AP1000 Design Certification Review

Westinghouse Electric Company

Advisory Committee on Reactor Safeguards

June 3, 2004

Bottom Metal Pool?

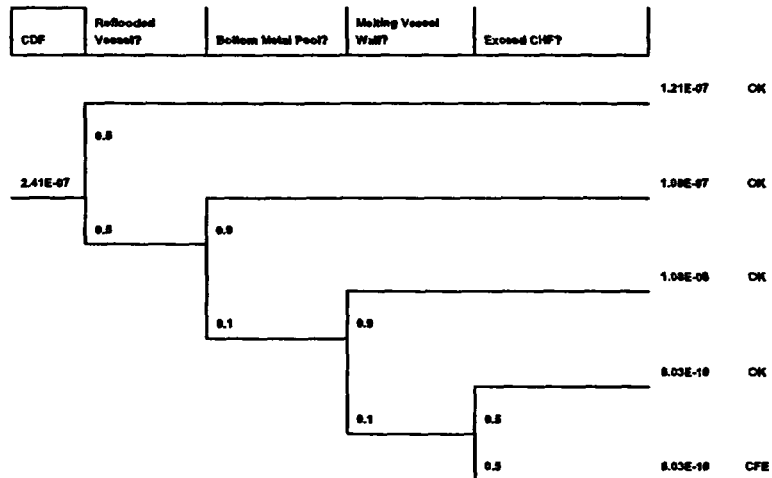
- **In-vessel debris relocation prevents large-scale mixing of molten Zr with UO_2**
 - Zr frozen at top of support plate
 - Oxide crusts prevent mixing
 - No uranium formation
 - No bottom heavy metal pool
- **Failure probability assigned = 0.1**

Issue 6: Organic Iodine Production

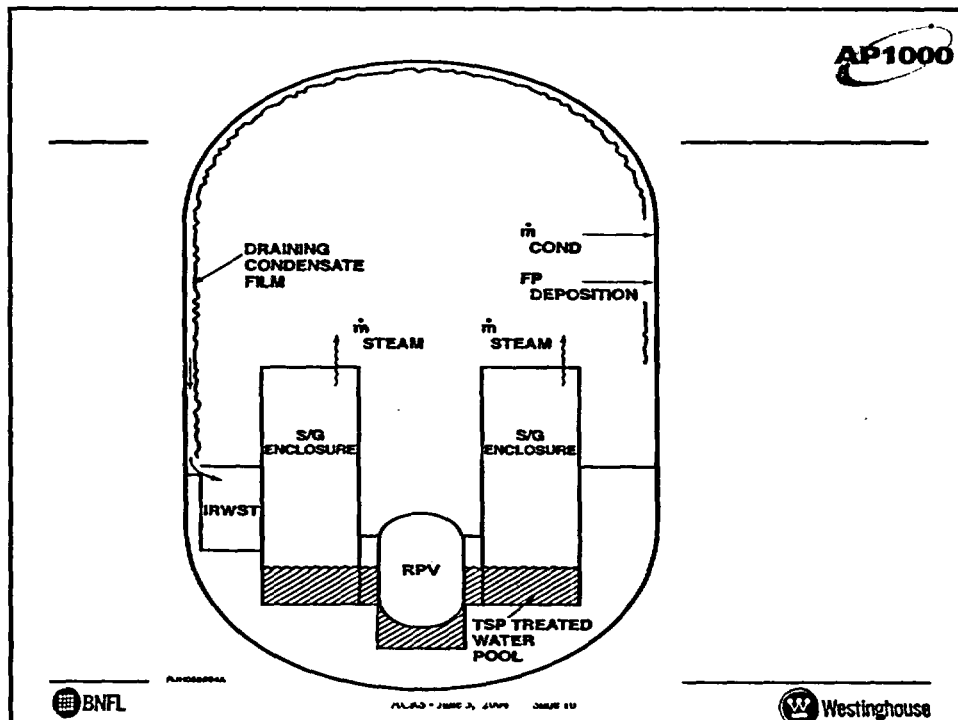
- Formation of organic iodine as a result of radiolysis or organic materials involves the availability of elemental iodine (I_2).
- Elemental iodine can be produced from iodide (I^-) in water pools or films where pH is not controlled to be 7 or greater.

- AP1000 containment design includes TSP to control the pH of the water pool that collects in the lower compartment and reactor cavity following an accident.

- However, no specific pH control treatment for the condensate film draining down the containment dome and shell is provided.
- Cesium iodide can be deposited on the draining film and provide a source of I^- that could potentially be converted in the film to I_2 given the film was acidified.

- Film residence time depends on the steam condensation rate and limits the amount of film acidification and CsI deposition. A range of 40 to 260 seconds has been estimated for condensation rates of 29 to 2.3 kg/s.

Issue 6: Organic Iodine Production

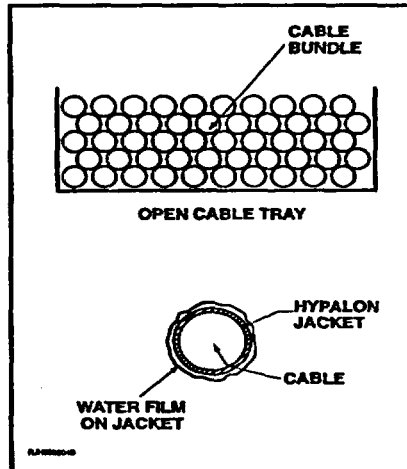
- Radiolytic decomposition of electric cable jacket material can produce HCl. If the HCl could escape the uncovered and covered cable trays, it could eventually mix with the containment atmosphere and be delivered to the draining film with the condensing steam.
